**REHABILITATION, OVERLAY AND BIKE
IMPROVEMENTS ON MYRTLE AVENUE (F3K300) PM
1.55-3.77
PROJECT NO.: RPL-5904(188)
CONTRACT NO.: 221060 & 342001**

ADDENDUM NO. 1

REHABILITATION, OVERLAY AND BIKE IMPROVEMENTS ON MYRTLE AVENUE (F3K300) PM 1.55-3.77 PROJECT NO.: RPL-5904(188) CONTRACT NO.: 221060 & 342001

ADDENDUM NO. 2

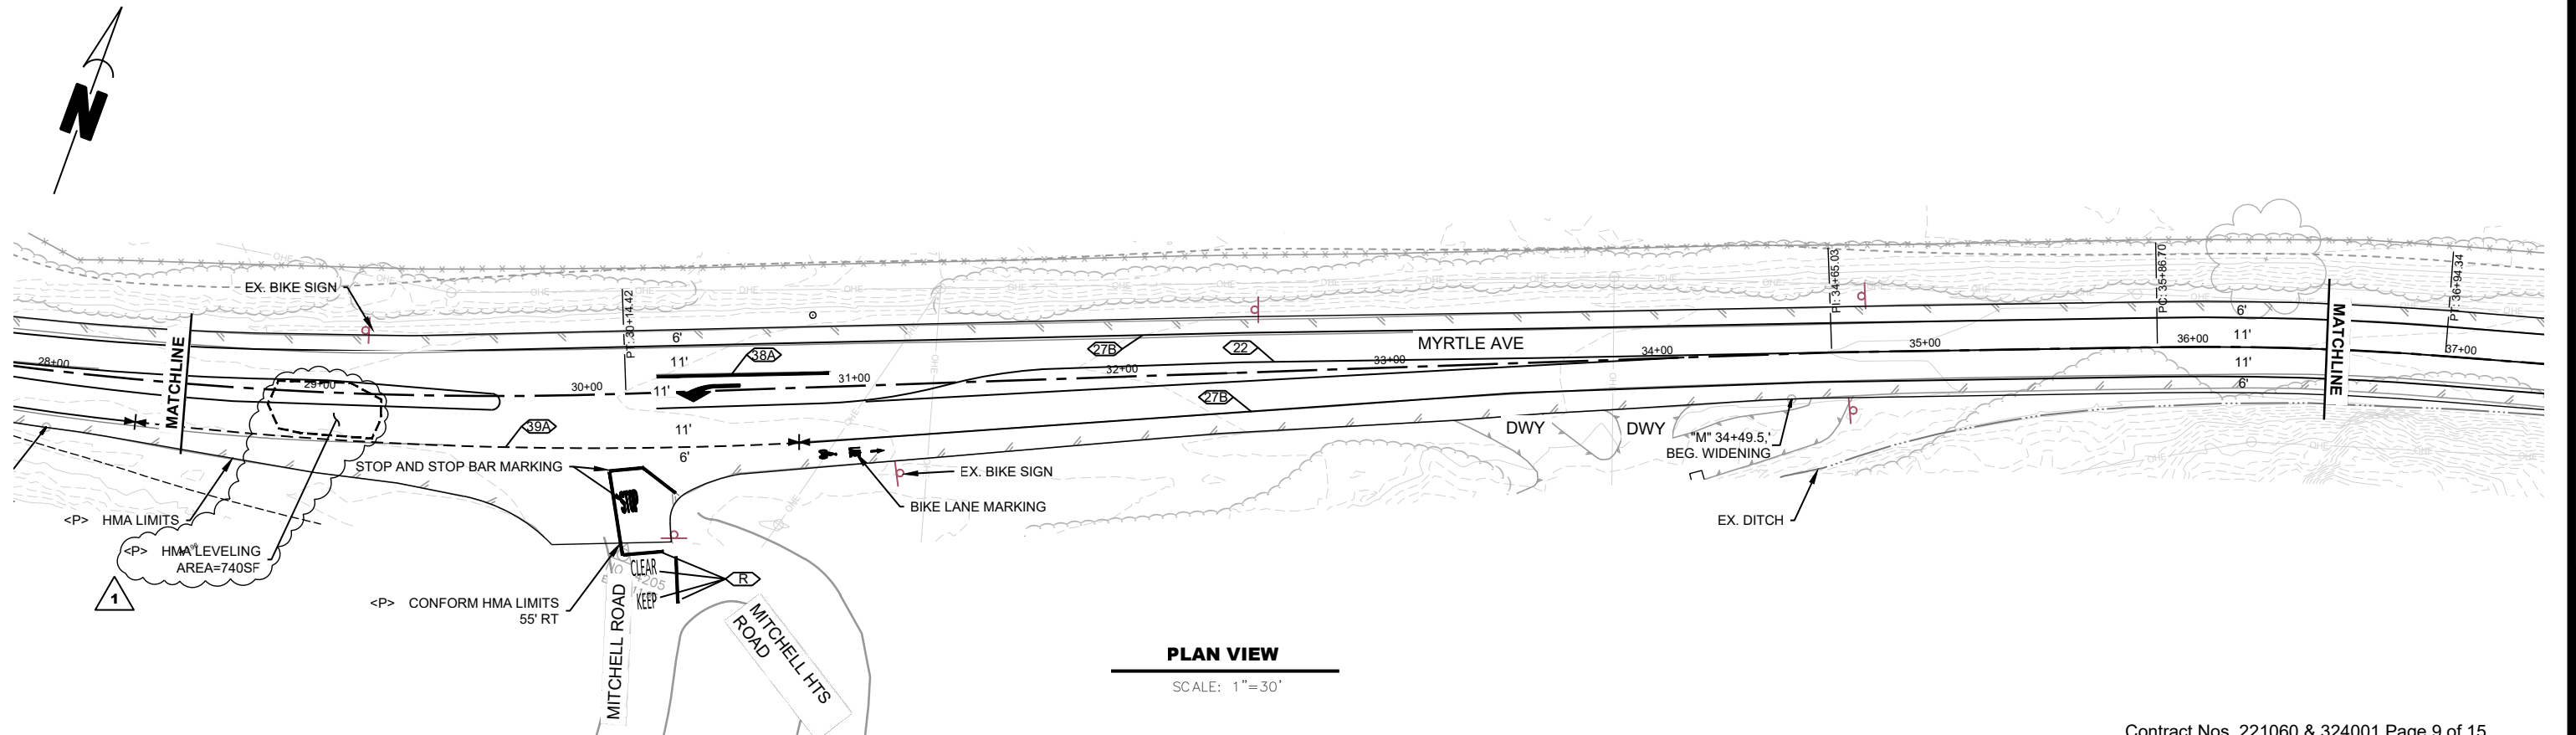
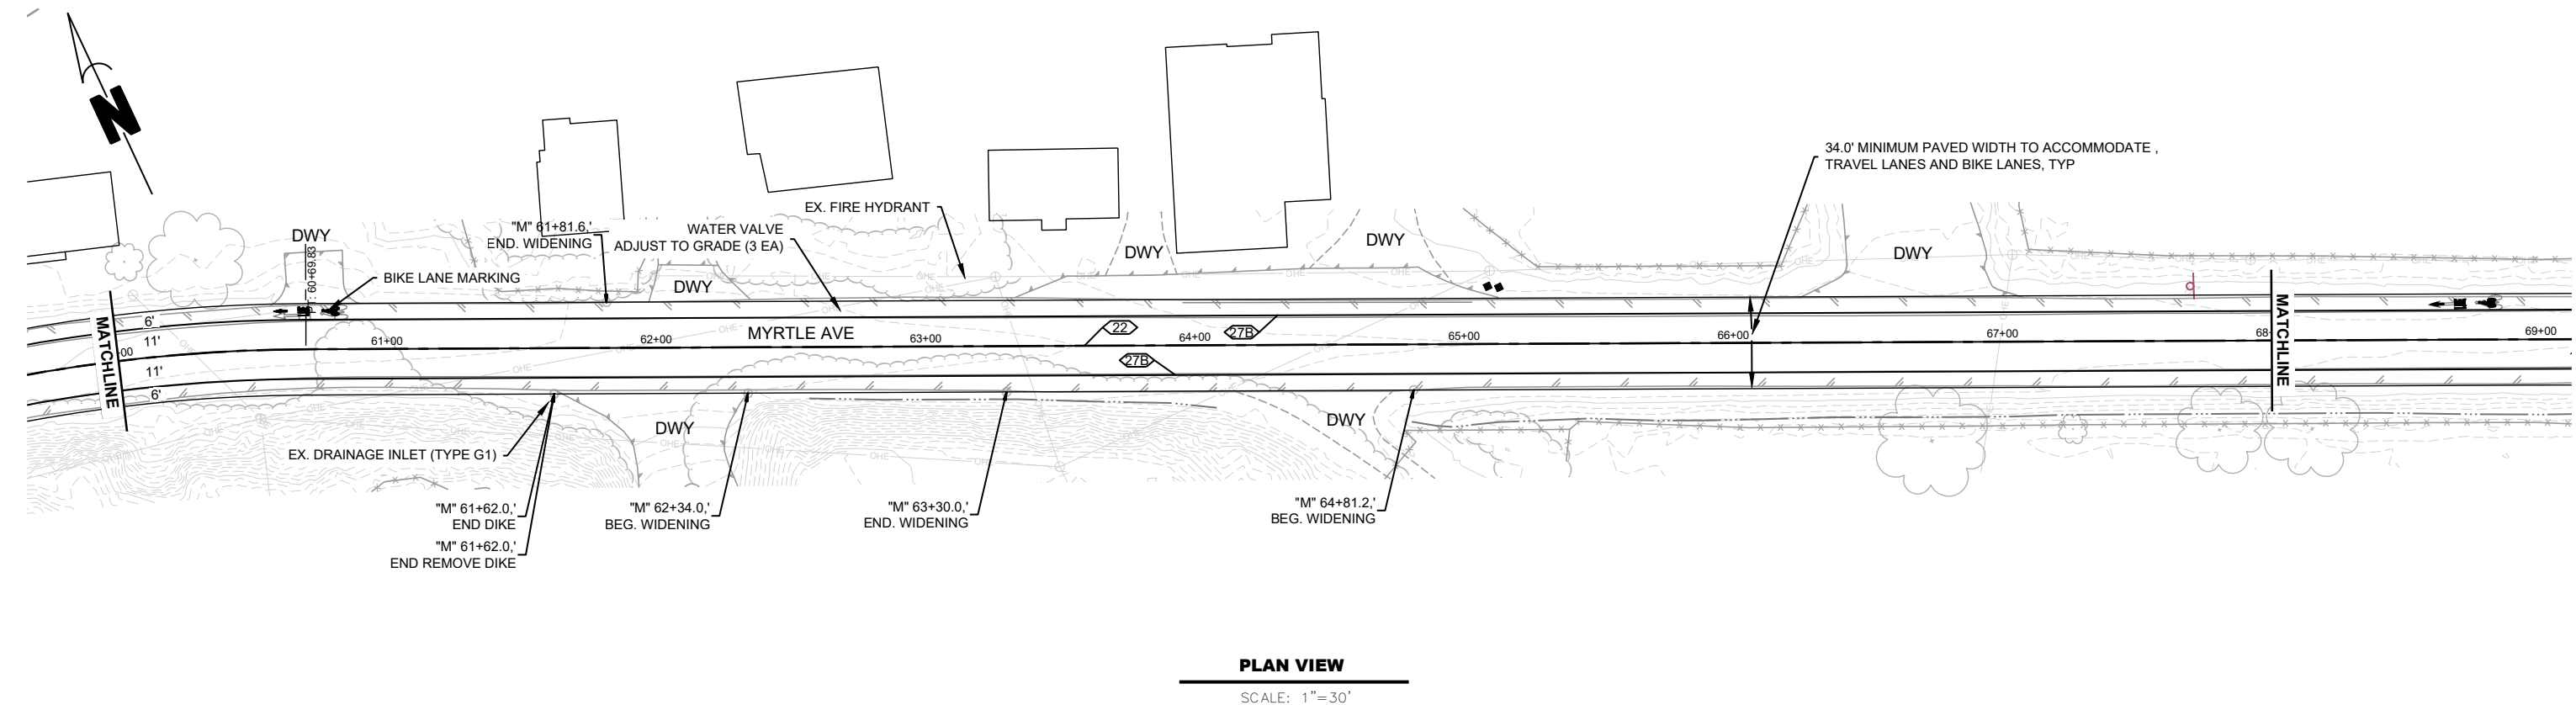
1. Contractor shall stockpile coldplane asphalt material at the staging/stockpile area located at the intersection of Freshwater Road and Myrtle Avenue. Coldplane asphalt material shall become property of the County.
2. HMA leveling shall be placed near station 29+00 right lane (Area=740sf) and at 57+00 right shoulder/driveway (Area=415sf). The purpose for HMA leveling is to improve drainage at the two locations. Revised Plan Sheets 7 and 9 show the approximate location and limits of HMA Leveling.
3. The Daylight Line for structure excavation of the curb-gutter and gabion is added to Revised Plan Sheet 9.
4. The Supplemental Project Information table listed in Section 2-1.06B of the Special Provisions shall include "Myrtle Avenue (F3K300) PM 1.55-3.77_C Line Profile_Supplemental_2026-03-24.pdf."

1. Addendum No. 1 Revised Plan Sheet 7 Myrtle Avenue PM 1.55-3.77
2. Addendum No. 1 Revised Plan Sheet 9 Myrtle Avenue PM 1.55-3.77
3. Myrtle Avenue (F3K300) PM 1.55-3.77 "C" Line Profile Supplemental
